Date: May, 2022

Design Change of Aluminum Disk Handwheel HDA/HDA-N

■ Appearance (1 Part Number Excerpt)

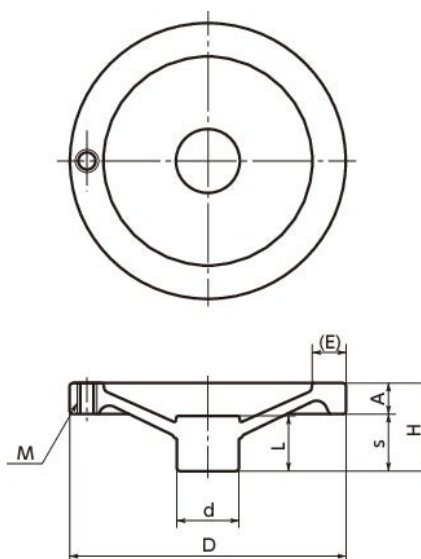
Specifications will be changed to further improve quality.

The surface of the rim around the outer circumference will be made smoother, and the outside diameter dimension (D) will be changed as follows.

Part Number	Before Change	After Change
HDA-80 HDA-80-N	82	80
HDA-100 HDA-100-N	103	100
HDA-125 HDA-125-N	128	125
HDA-160 HDA-160-N	164	160
HDA-200 HDA-200-N	204	200
